DOWN KINR 12 NOV 29/62 11:15A  
A STERMAC MATERIALS AND RESEARCH  
RE HWY 401 WOOD CREEK CONT 62-82

Re: W.P. 188-60  
Hwy. 401, Service Road  
at Wood Creek

W.P. 117-59  
Lancaster Twp. Br. #13  
Hwy. 401 at Wood Creek

Preliminary Plan  
Approval, Dist. 9

**PRELIMINARY PLAN**

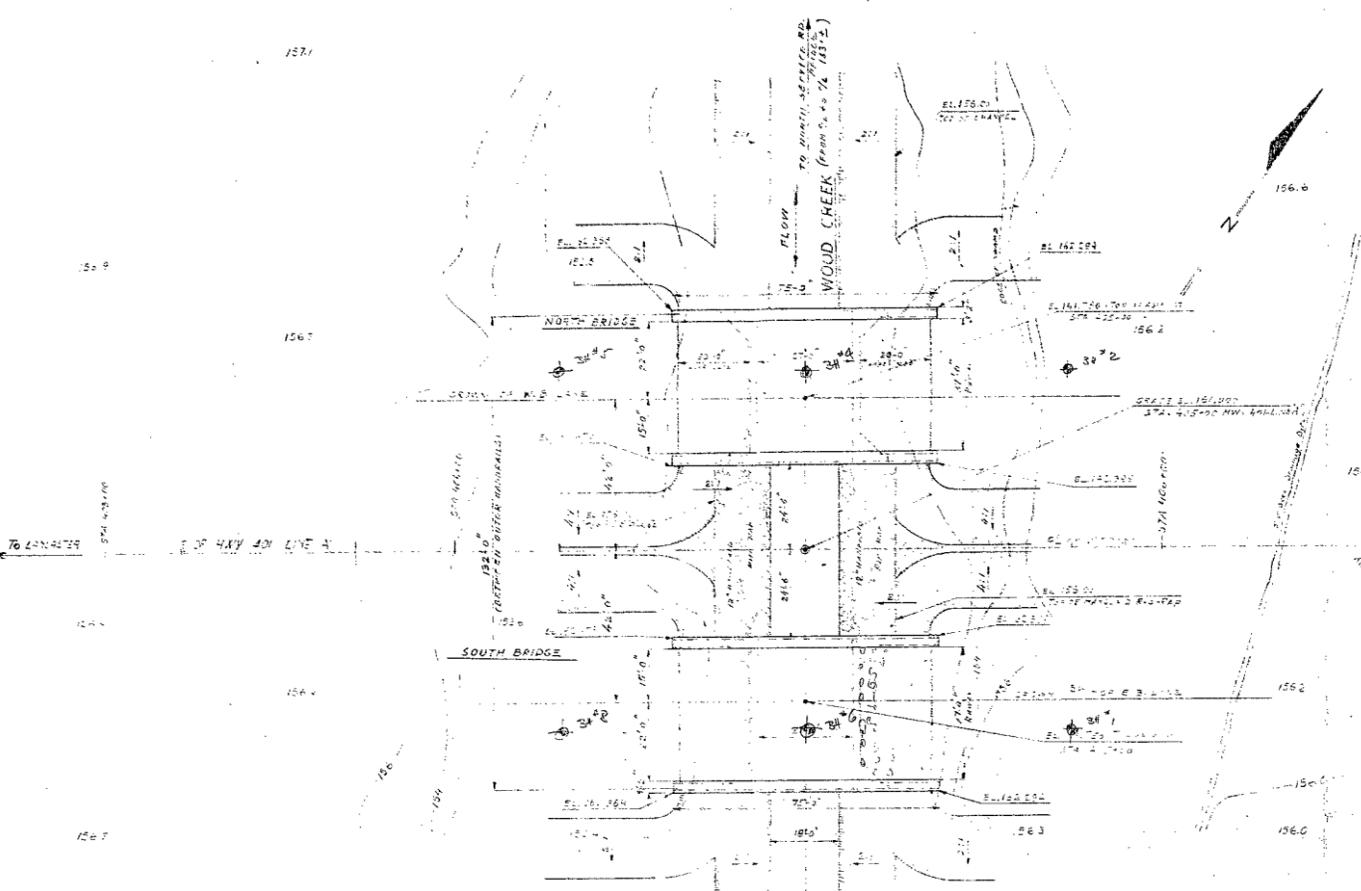
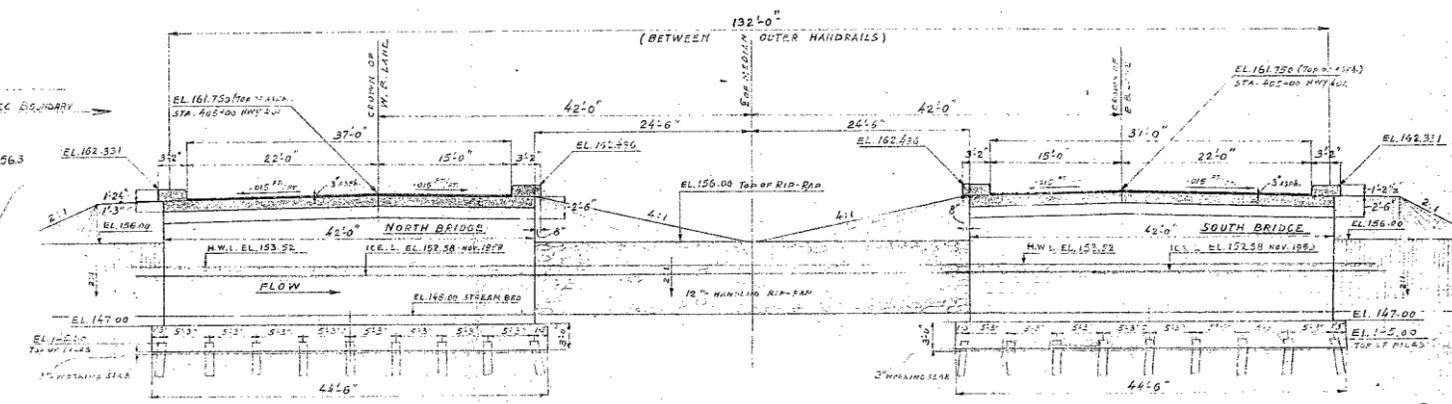
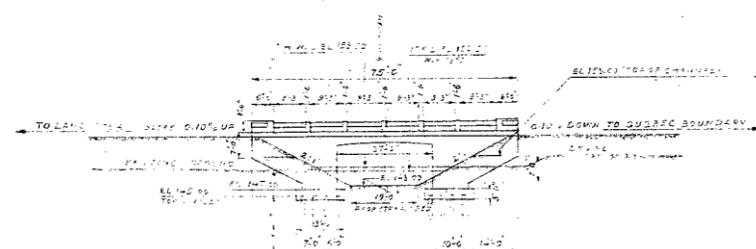
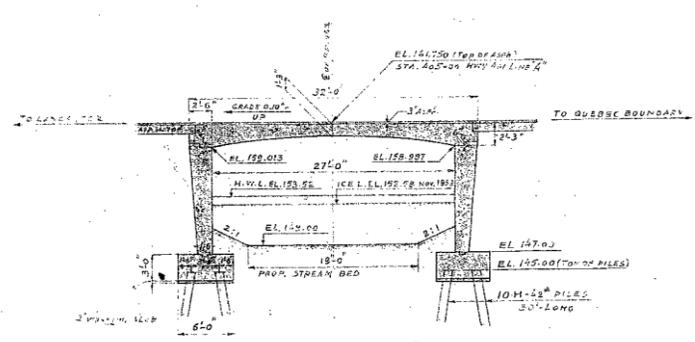
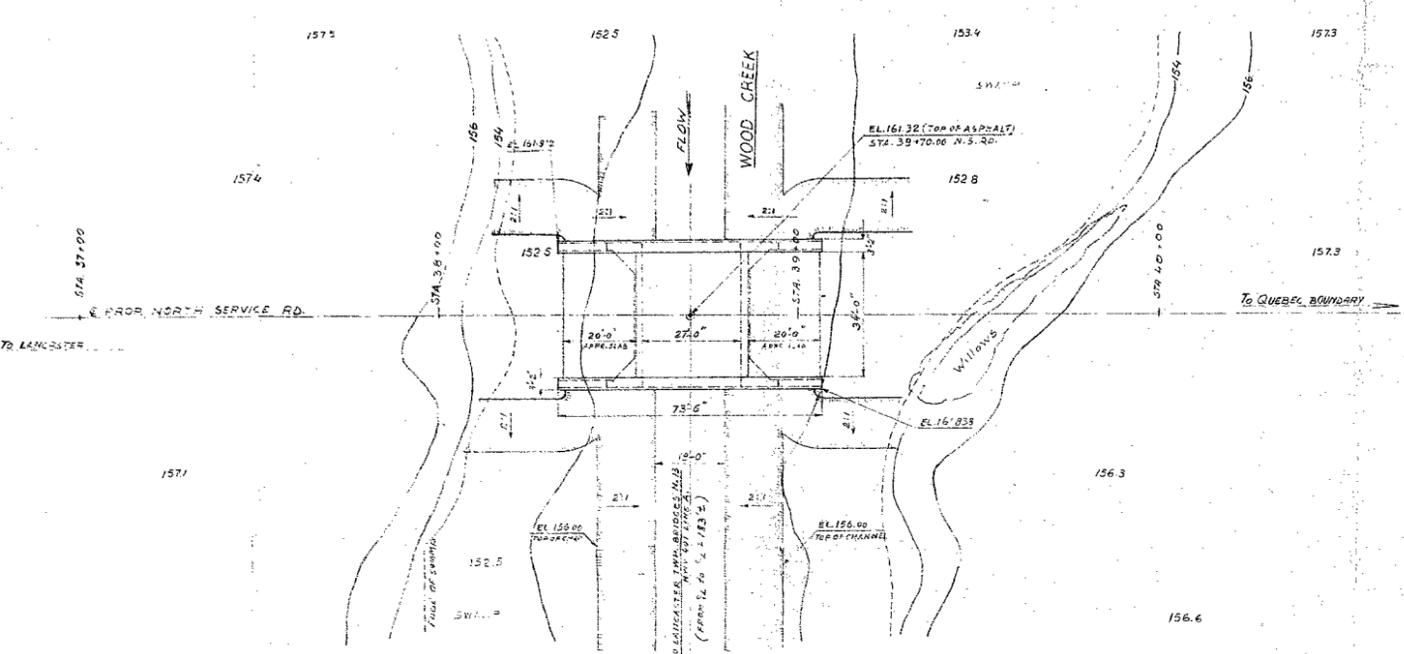
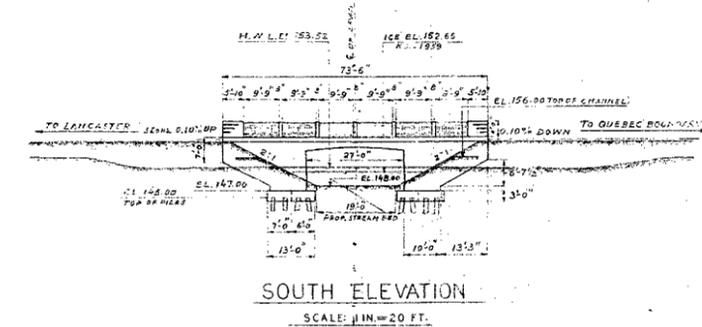
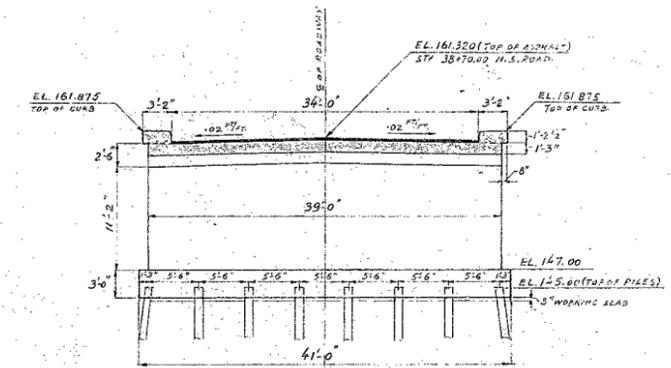
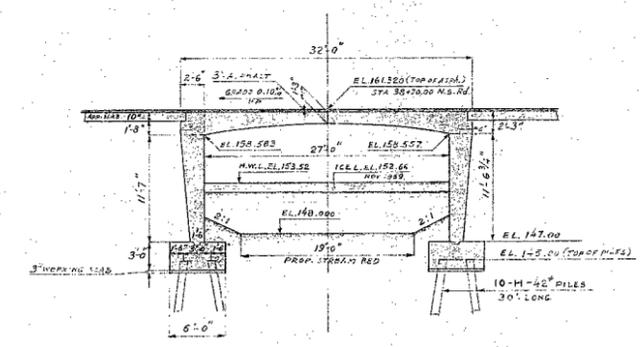
The designer appears to have followed all the recommendations of the foundation reports except that the approach fills appear to be seven or eight feet high. The reports state that five foot approach fills will have negligible settlement but make no statement on seven or eight foot fills.

Would you also consider putting  $1\frac{1}{2}:1$  slopes at these structures if the slopes are rip-rapped with pre-cast concrete slabs?

We have received and reviewed the preliminary plans for the above mentioned structures. The rising of the embankment fill from 5 - 7 or 8 feet in height will have some influence on the amount of settlement, but we think that this increase of settlement should not be a cause for any change in the design. A certain maintenance of the approach embankment pavement will be required.

As to the question of changing the slopes from 2:1 to 1½:1, we have no objection. The overall stability of the approach fill is adequate and the stability of the slope itself depends on the compaction of the material. Therefore, supervision of the compaction of this portion of the fill should be kept very close to see that the compaction specifications are met.
